**Subject: Interim Remedial Measures Work Plan – Amendment #2  
Former Sperry Remington Site – North Portion (#c808022)  
777 South Main Street, City of Elmira, Chemung County, NY**

**ATTACHMENT 2**  
**CONSTRUCTION DRAWING**

Description of Activities: Soil sampling locations for Pile A.

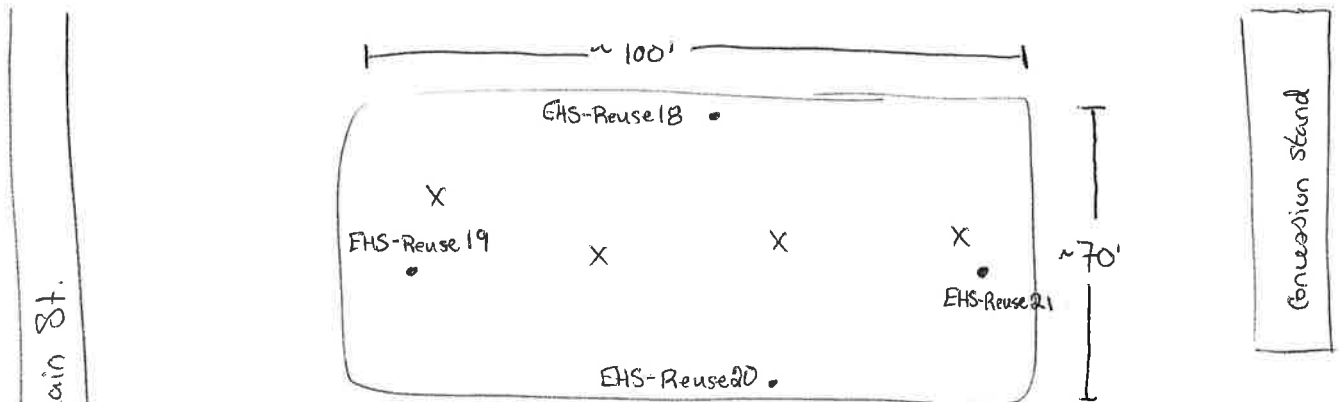
I have reviewed the 24 August 2017 request to reuse stockpile A soils package. Chemical analyses of the soil, completed by the ELAP certified lab Alpha Analytical and validated by Alpha Geoscience on August 11 and 18, 2017, indicates the minor exceedance of DER-10 appendix 5 for Restricted Residential site use criteria for a few SVOC constituents in one of three composite samples.

PCBs were detected in three of three composite samples however concentrations were all below 1 mg/kg Restricted Residential criteria. Trichloroethene was detected in five of nine grab samples however concentrations were all below unrestricted use criteria.

Concentrations of SVOCs are not indicative of source levels of constituents and therefore may be re-used as requested below the asphalt tennis court cover systems at the Former Sperry Remington – North Portion Site #C808022.

Please provide “as-built” documentation of the area and depths where these soils are placed for future site management purposes.

1 PLAN STOCKPILE AREA

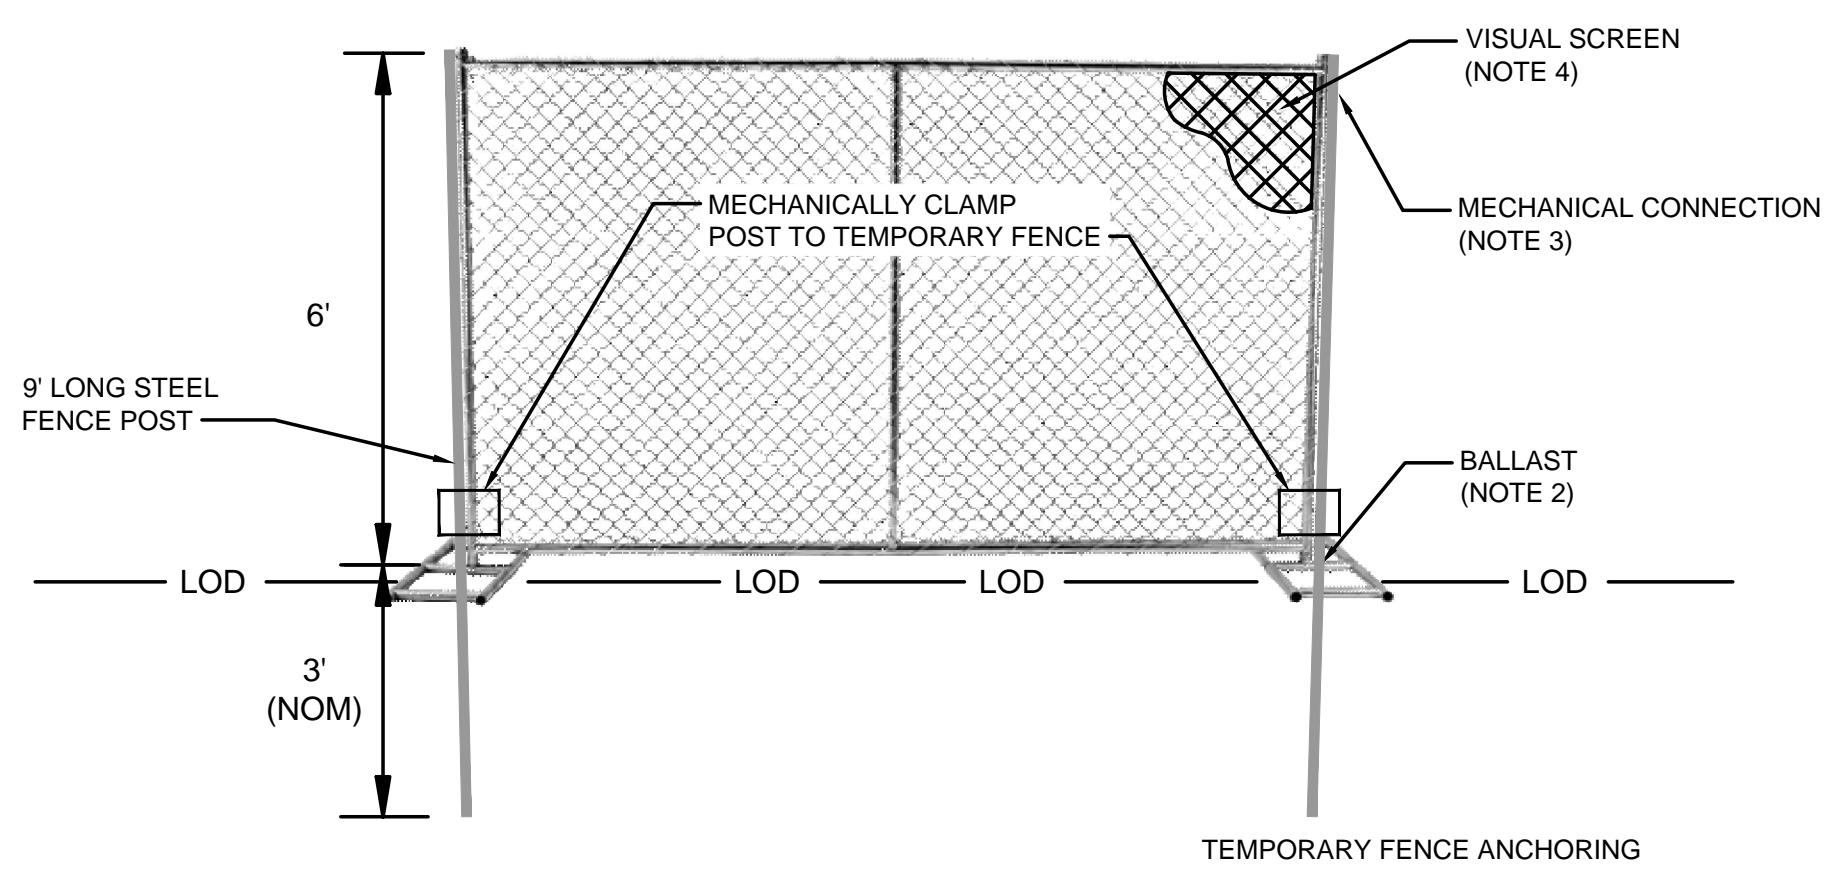
Upon arrival at the MSA, trucks will unload in the area designated for EHS CIP stockpiles as shown on the Construction Drawing (**Attachment 1**). Depending on the volume of material, the entire designated area may not be utilized. Trucks will be unloaded in a manner that prevents contact with stockpiled soils outside of the secured bed of the truck. Therefore, decontamination will not be required in accordance with Sections 02057 and 02130 of the IRM Work Plan Construction Specifications. Unloading will be observed and documented by a qualified environmental professional (QEP).

As noted earlier, ECSD may request approval for reuse of additional material in the future. Upon NYSDEC approval, those materials will be transported to the MSA, unloaded in the area designated for future use shown on the Construction Drawing and secured separately as described above.

3 DETAIL EHS CIP SOIL STOCKPILE (FRONT VIEW)

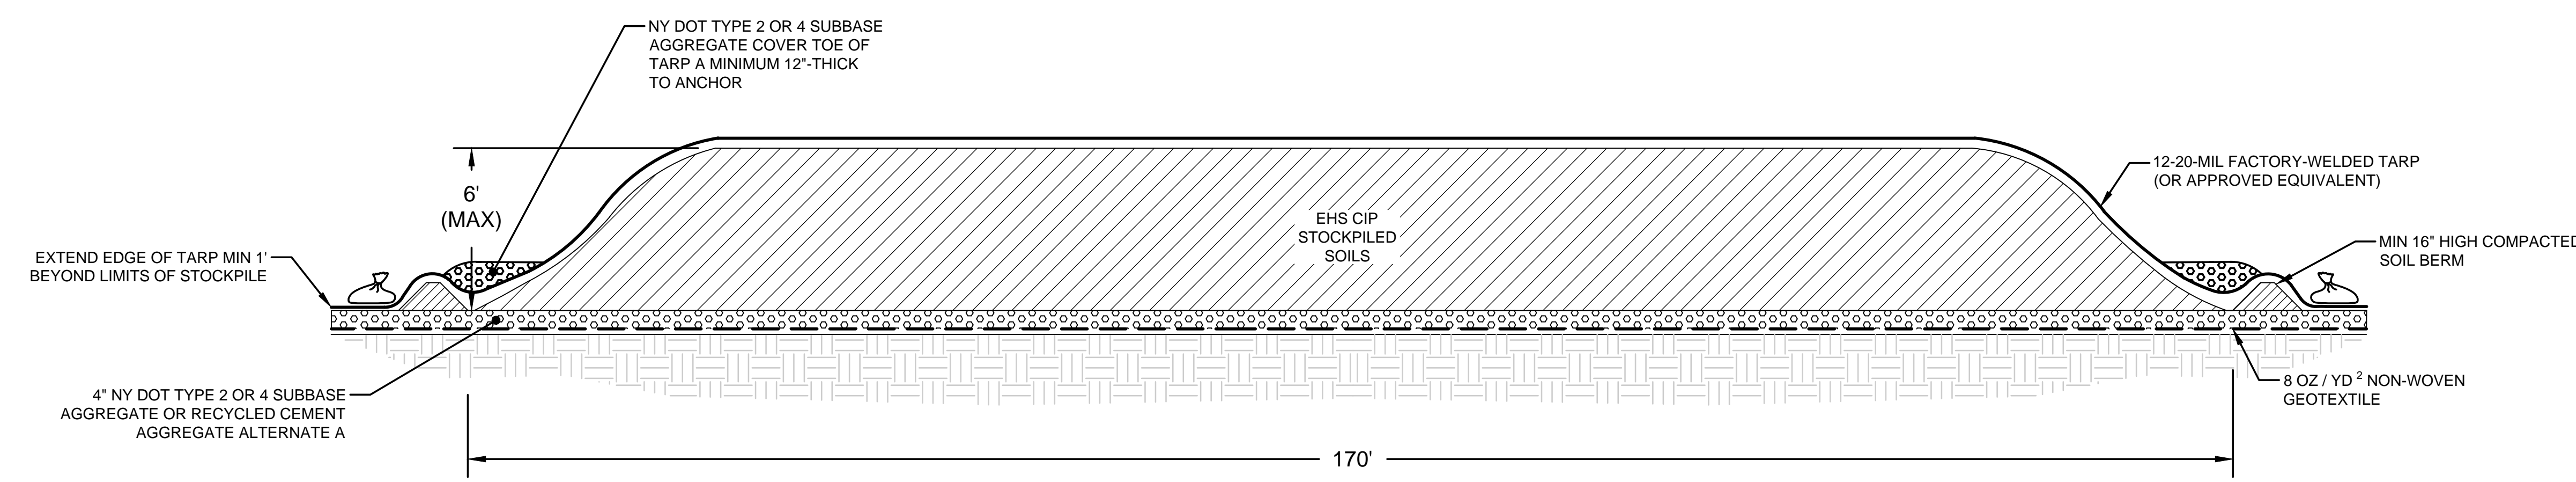
Unloaded soils will be stockpiled and stabilized to secure reuse soils and minimize the potential for contact with precipitation. As shown on the Construction Drawing, stockpiling of EHS CIP soils will include:

- Grading the stockpile to create a single pile no greater than six (6) feet tall (i.e., lower than the top of the fence);
- Covering the stockpiled soils with a heavy-duty tarp (e.g. 12 to 20 mil thickness) that is designed for longer term exposure. The tarp will be manufactured into a single large panel so it will cover the stockpile without requiring unwelded, overlapping panels that could catch the wind;
- Placing gravel at the base of the stockpile so that the tarp is secure and runoff from the tarp gets slowed down before hitting the ground; and

- Placing sandbags at the base of the berm so that the tarp is secure.

- NOTES:
1. CONTRACTOR SHALL UTILIZE EARTH DIKE, COMPOST FILTER SOCK, AND DEWATERING SUMP PIT.
  2. CONTRACTOR SHALL PLACE A HEAVY-DUTY TARP (12 TO 20 MIL THICKNESS) THAT IS DESIGNED FOR LONGER TERM EXPOSURE OVER THE ENTIRE STOCKPILE. THE TARP SHALL BE FACTORY-WELDED BY THE MANUFACTURER INTO A SINGLE LARGE PANEL TO COVER THE STOCKPILE.

3. CONTRACTOR SHALL PLACE GRAVEL AROUND THE ENTIRE PERIMETER BASE OF THE TARP SO THAT IT IS SECURE AND RUNOFF FROM THE TARP IS SLOWED BEFORE RUNNING ONTO SURROUNDING GROUND.
